## ADDENDUM

**ADDENDUM NO.:** 04  
**PROJECT NAME:** Emergency Medical Services (EMS) Addition  
**PROJECT NO.:** 07215  
**CONTRACT NO.:** C1611  
**DATE OF ISSUE:** July 31, 2024

### NOTICE OF CHANGES, MODIFICATIONS, OR CLARIFICATIONS TO CONTRACT DOCUMENTS

**1** TRANSITION OF ROOF TO EXT. WALL  
Scale: 3" = 1'-0"

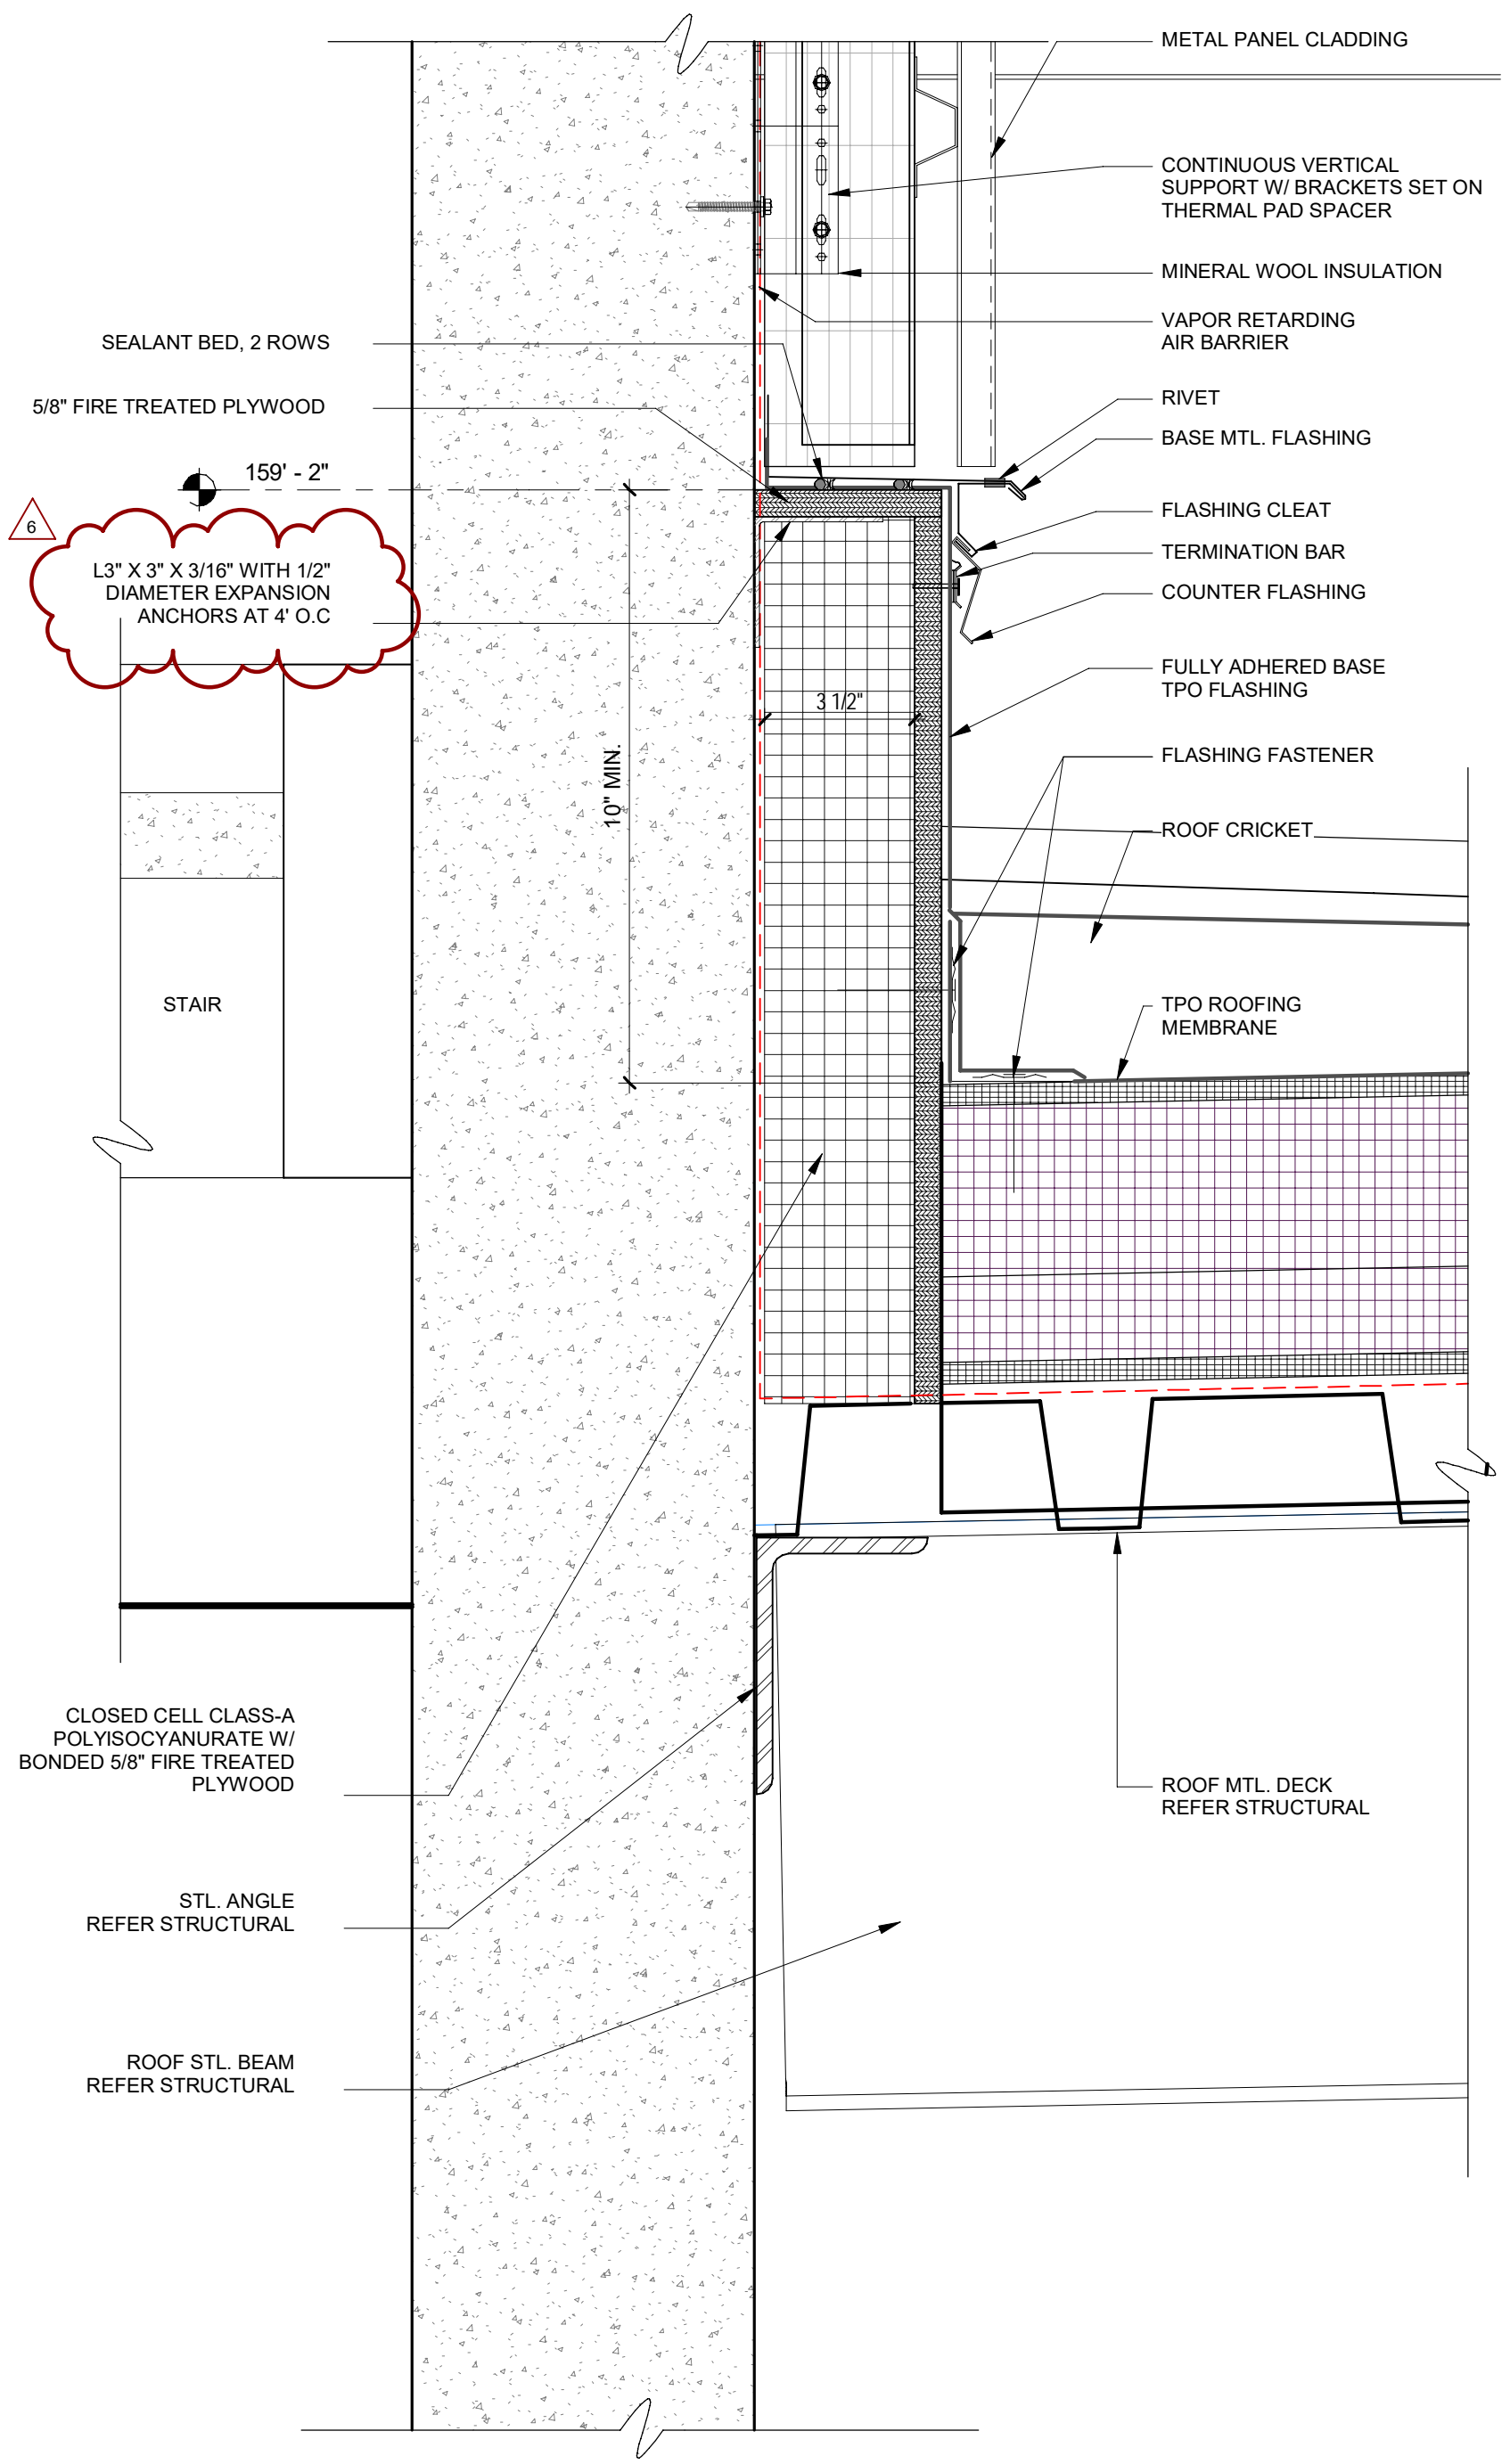
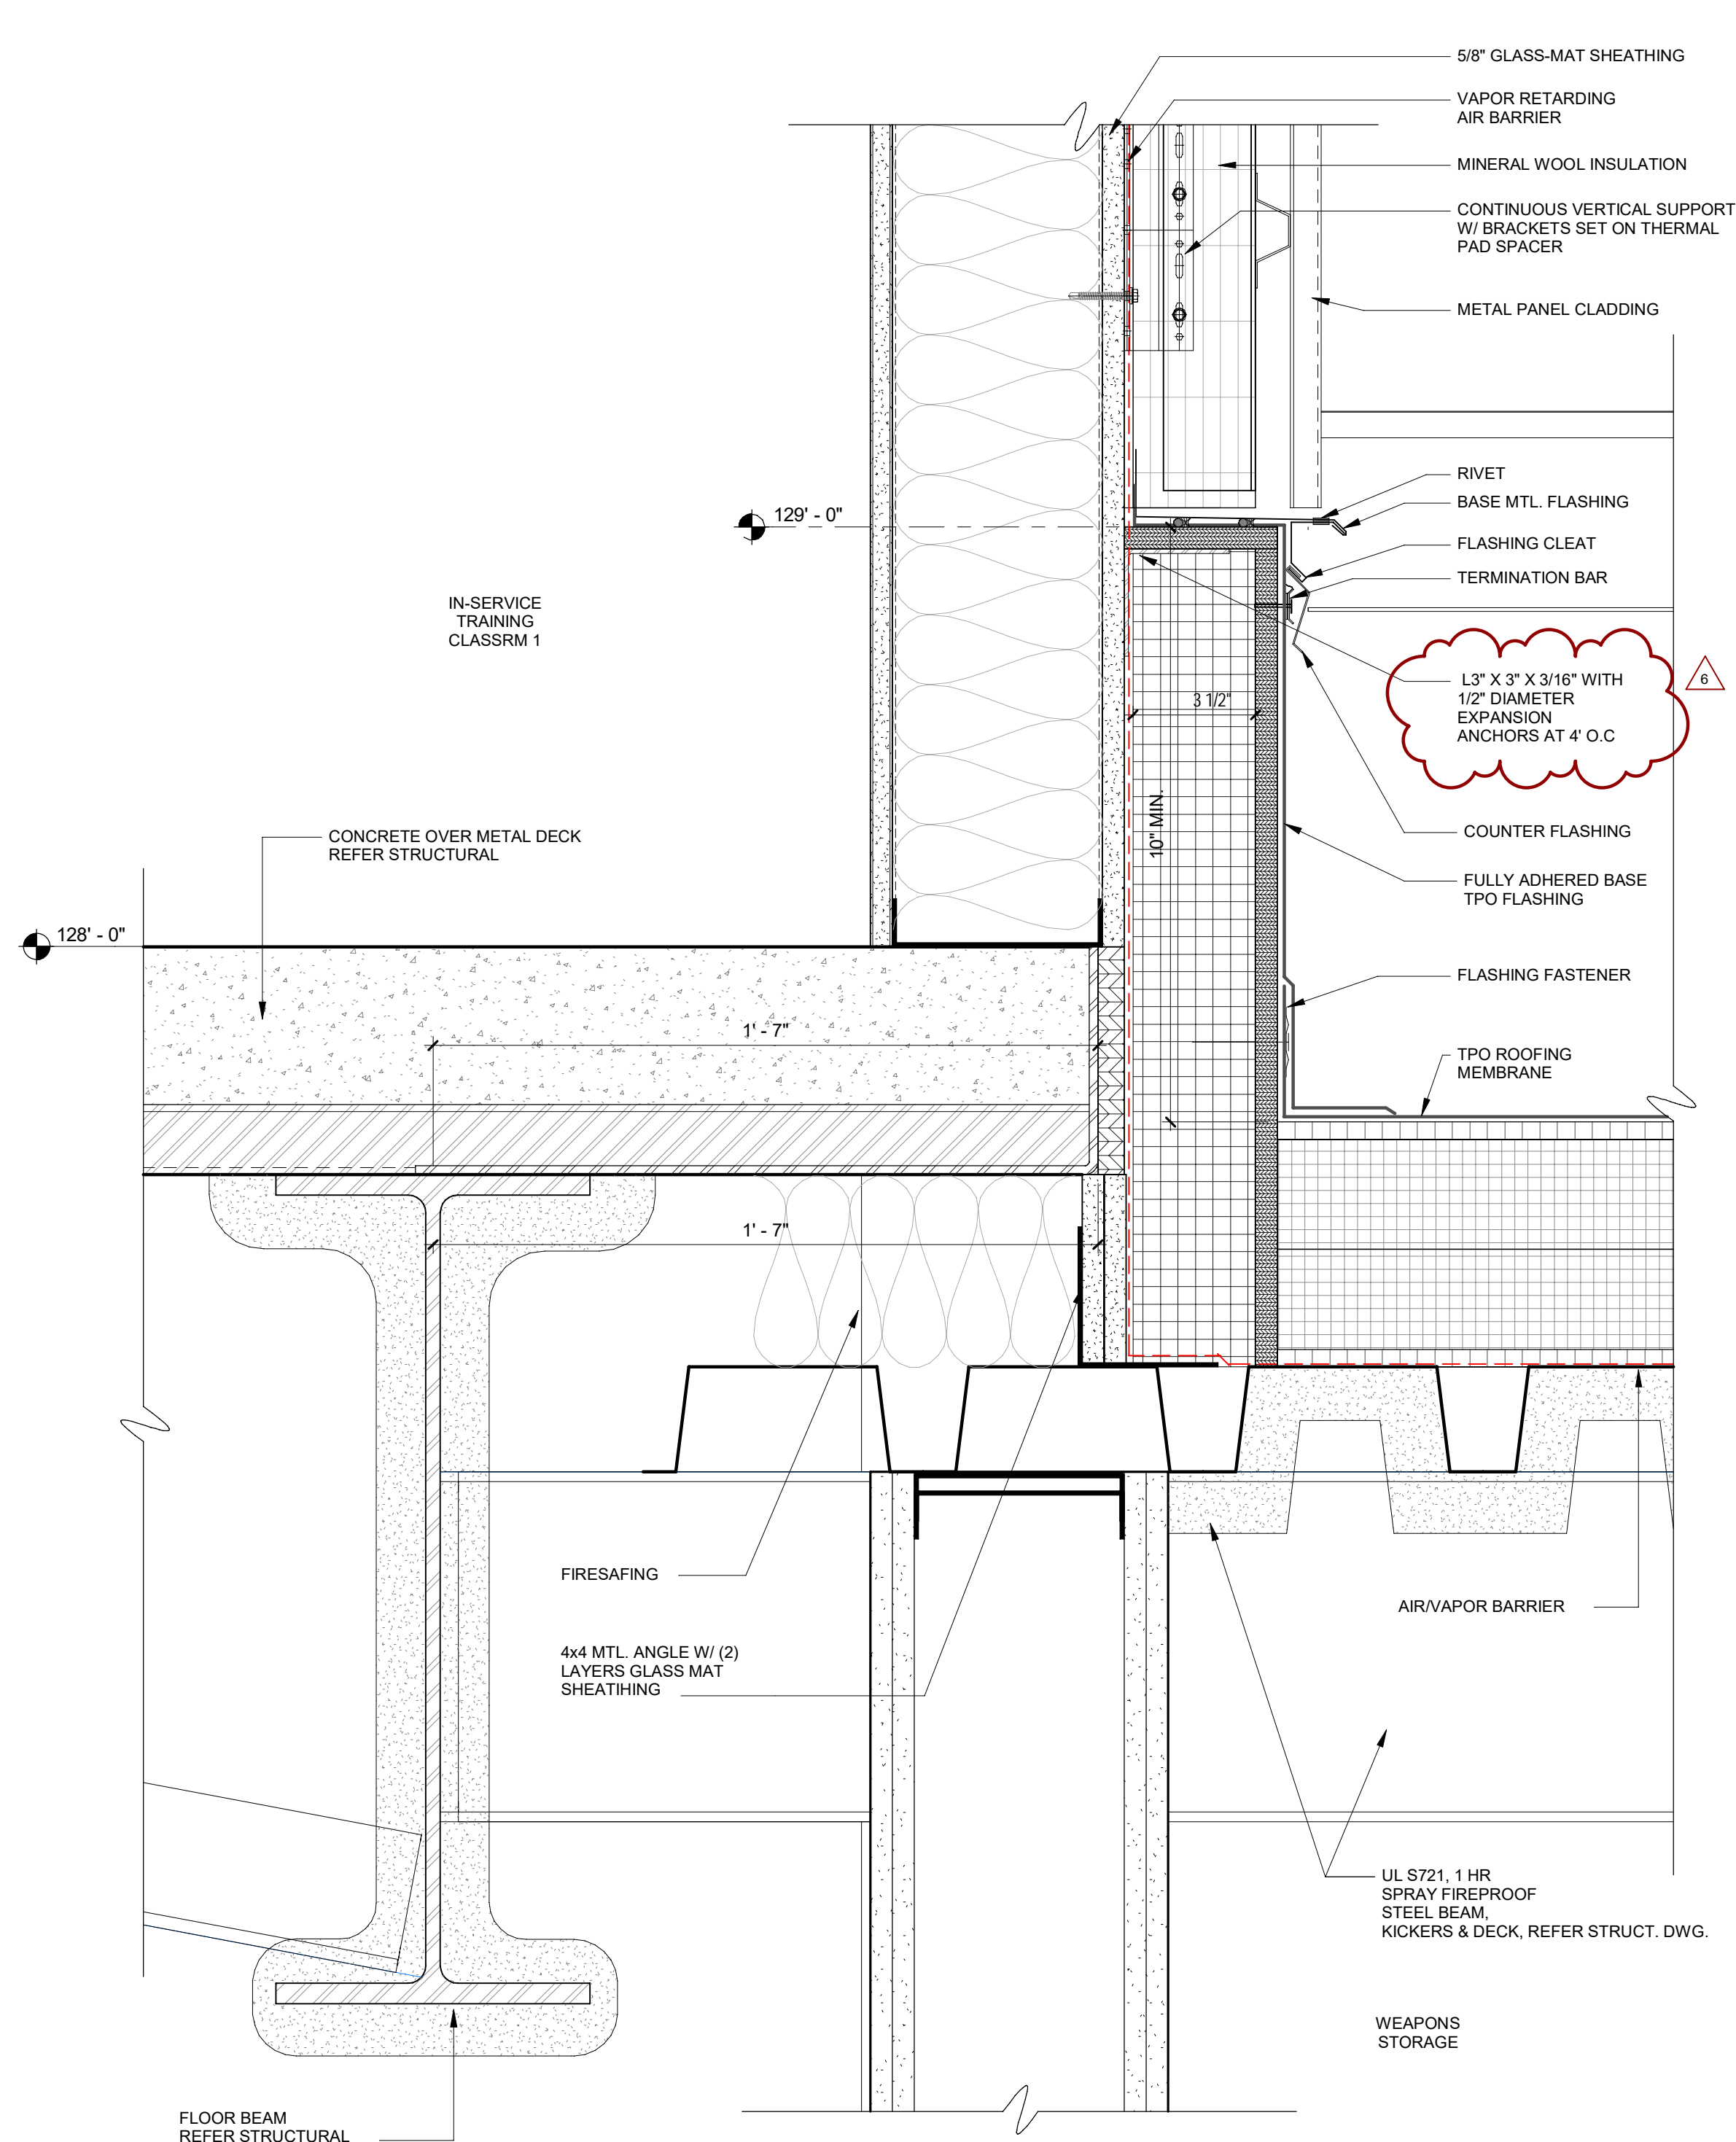
- Change 11** **REVISED** Drawing No. A402 – Updated Detail 25.
- Change 12** **REVISED** Drawing No. A522 – Added notes for corner angle
- Change 13** **REVISED** Drawing No. A602 – Updated Detail 7.

**Question:** Regarding Sheet A522 Details 1 to 3, there is a 3x3 corner angle shown that is not present in the structural drawings. Can more information be provided this angle?

**Response:** Provide continuous L3" x 3" x 3/16" with 1/2" diameter expansion anchors at 4' O.C. Please refer to revised Sheet A522 included in this Addendum 4.
